Internal Memo No. 912/34/1 – Construction Division

Subject:- Finishing near kitchen and bathroom windows

MODI
PROPERTIES

FINISHING OF TILES NEAR WINDOW AND VENTILATOR

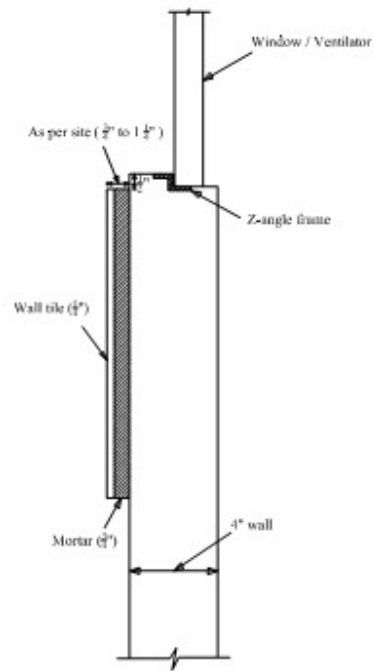
The finishing near window sill in kitchens / utility and ventilators in bathrooms, where tiles are touching such windows and ventilators is very poor. To correct the situation a ½” by 1” step should be made near the ventilators/windows.

A drawing and photograph of the proposed step is enclosed.
